Origination Form
Proposed Revisions to a Standard Plans Index

Originator:	Gray, Ryan	Index Number:	711-003
Date:	8/6/2025	Sheet Number(s):	6
E-mail:	ryan.gray@dot.state.fl.us	Index Title:	Interchange Markings

LAST REVISION 11/01/21	DESCRIPTION: 11/01/25	FDOT FY 2025-26 STANDARD PLANS	INTERCHANGE MARKINGS	INDEX 711-003	SHEET 6 of 8
--	-------------------------------------	---	-----------------------------	-----------------------------	----------------------------

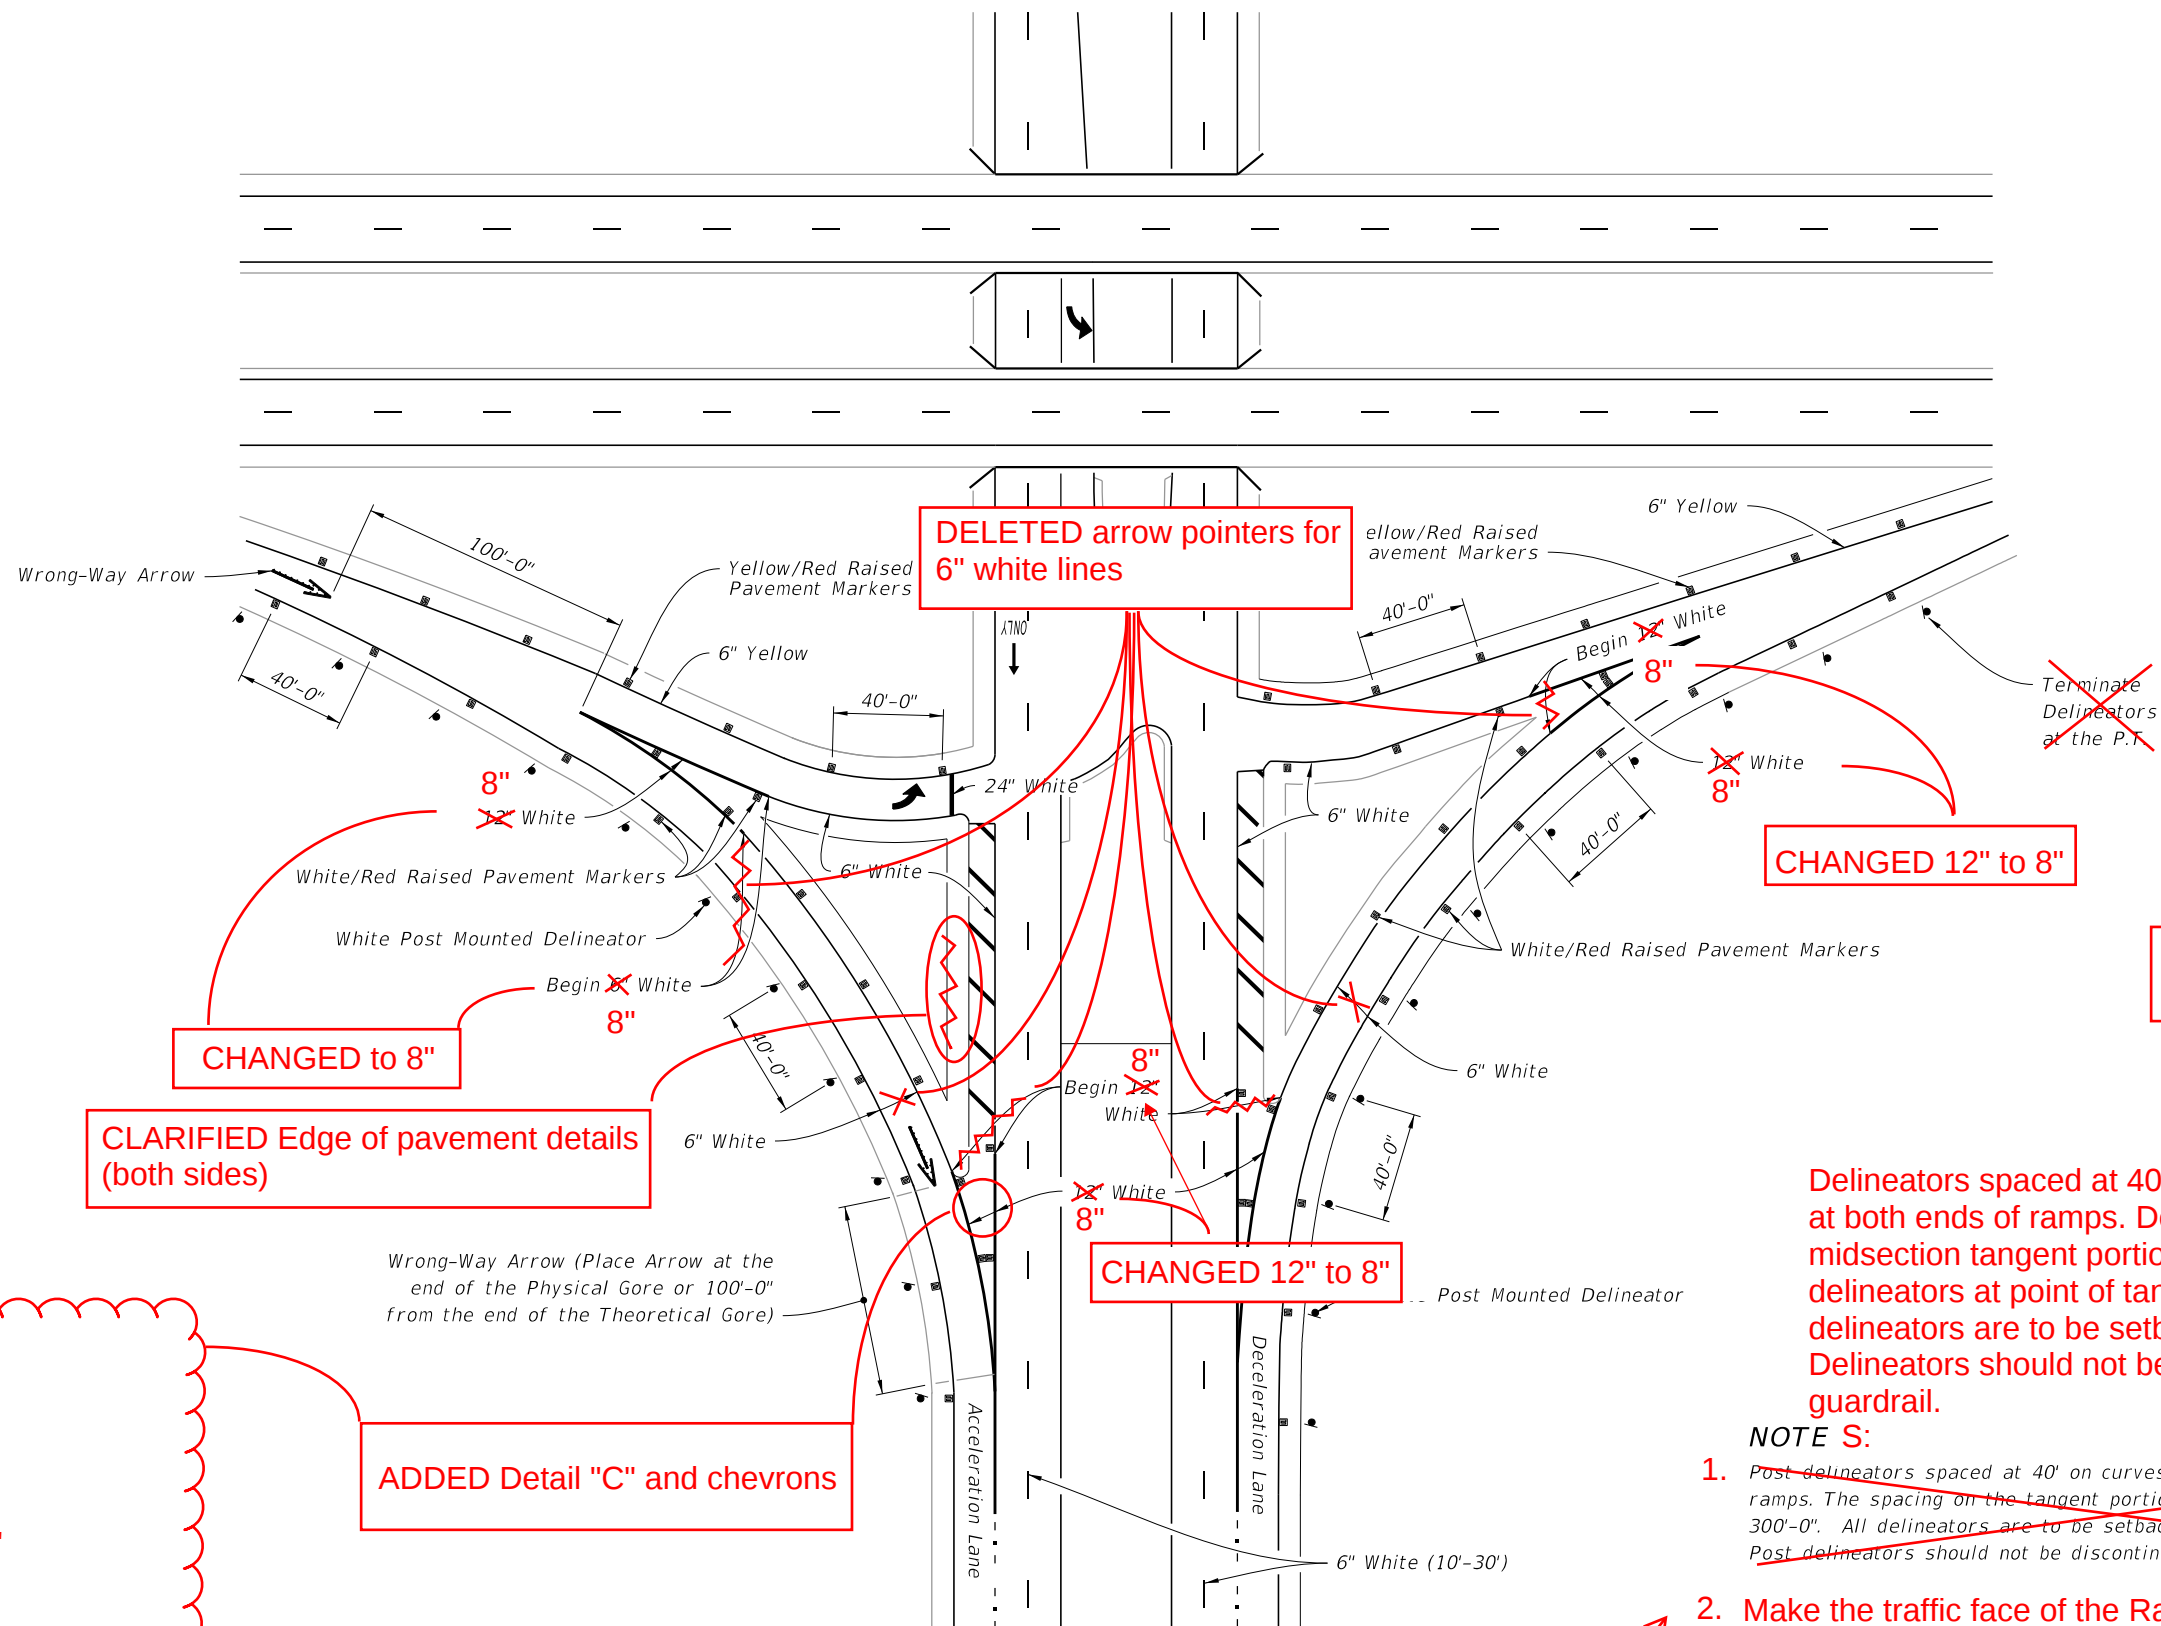
Sheet 6: DELETED arrow pointers for 6" white lines; CHANGED 12" to 8"; UPDATED Note 1; ADDED Note 2; ADDED Detail "C"; ADDED chevron markings to gores; CLARIFIED edge of pavement details.

For traffic passing to the right of the gores at the collector ends of ramps, the inside edge line adjacent to the physical gore should be a wide white line, or a yellow edgeline, to be consistent with MUTCD guidance. Added Note 2 to clarify RPM color for either channelizing/edgeline option; Updated Note 1 to clarify delineator spacings and termination point; Added chevrons and related Detail "C".
